CITY OF VANCOUVER
POLICY REPORT
DEVELOPMENT AND BUILDING

Report Date: May 27, 2008
Author: Phil Mondor
Phone No.: 604.873.7727
RTS No.: 07154
VanRIMS No.: 11-3600-10
Meeting Date: June 10, 2008

TO: Vancouver City Council
FROM: Director of Planning
SUBJECT: CD-1 Rezoning - 1304 Howe Street

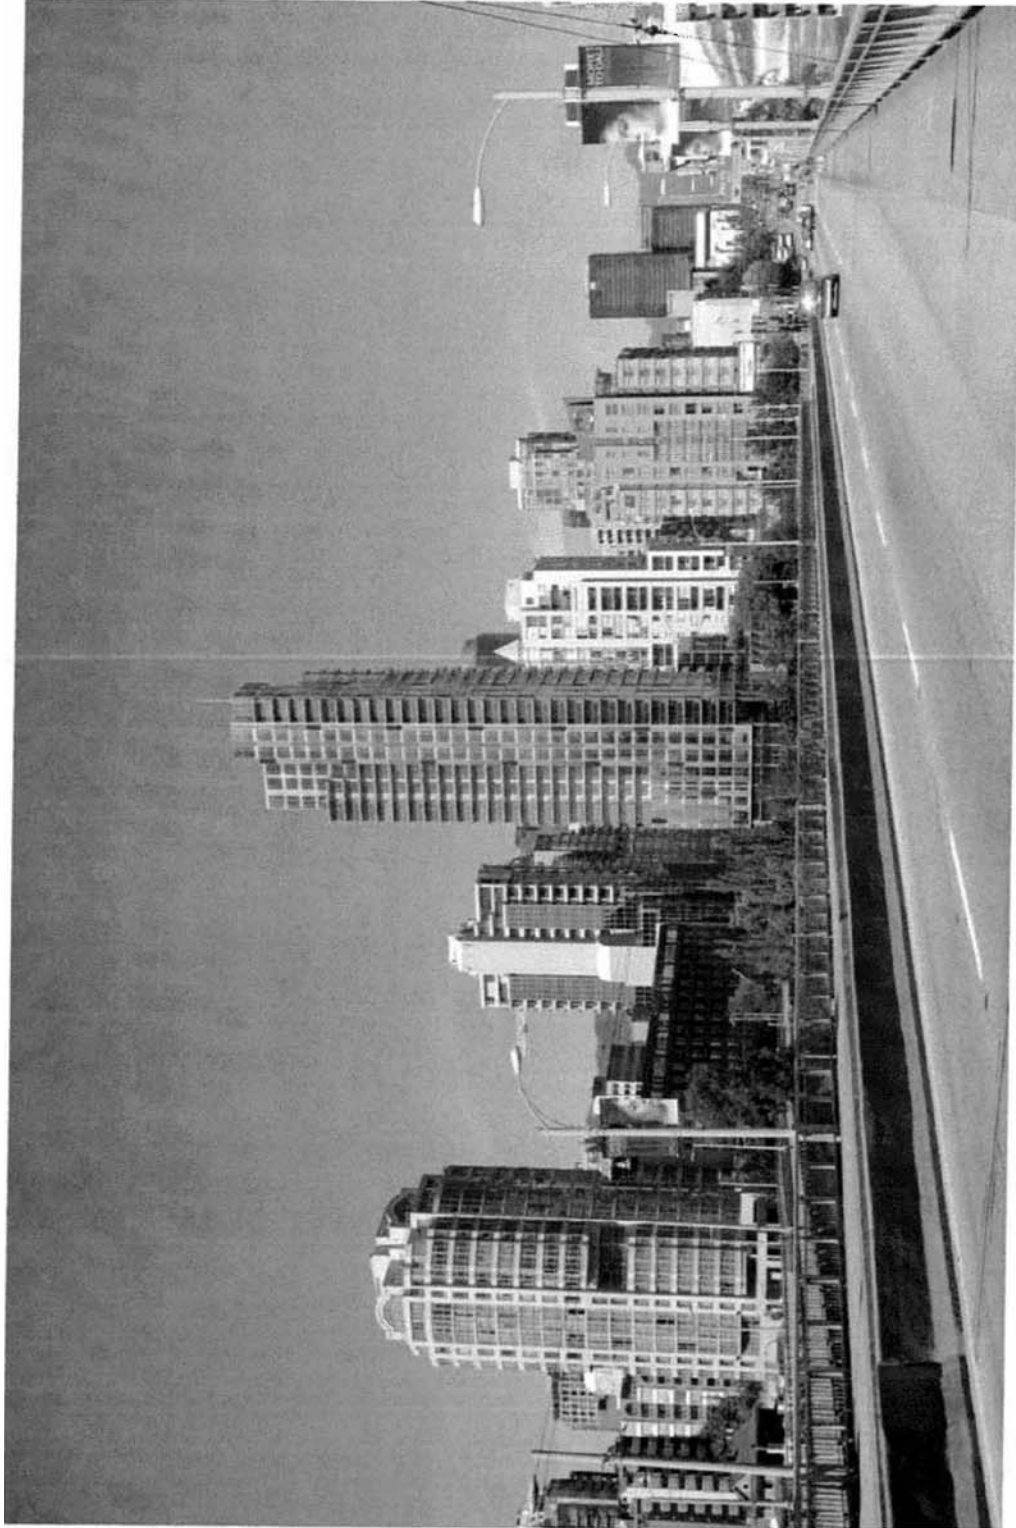
“The City’s Food Policy identifies both environmental and social benefits of urban agriculture and seeks to maximize opportunities for food growing activities in the city. On May 30, 2006, Council approved a motion calling for the creation of 2,010 new garden plots by 2010 as an Olympic legacy for Vancouver. These policy objectives can be met with the provision of rooftop and terrace gardens in high-density developments.

It appears would be possible to incorporate/convert some of the planters to informal plots and/or incorporate edible landscaping. It is not something that we would be requiring at this stage, but a heads up to the applicant that it may be something to consider for the DE stage; however, I also don't foresee this being a challenge to accommodate given the current design/layout.

In order to incorporate the City’s Food Policy objectives, design development is required to provide for edible landscaping in the planters bordering the outdoor amenity terrace. Edible landscaping is the use of plants that produce food in place of more commonly used ornamental plants. Many of these plants are beautiful, providing ornamental quality while also producing edible leaves, flowers, nuts, and berries. In this way, edible plants serve “double duty” by creating attractive outdoor spaces and gardens and by providing local, healthy, and delicious food.

Recommended Condition: Design development to utilize edible landscaping materials, with particular attention being paid to the use of edible shrub plantings that provide all season interest, for use in the planters bordering the amenity patio on level 3.”
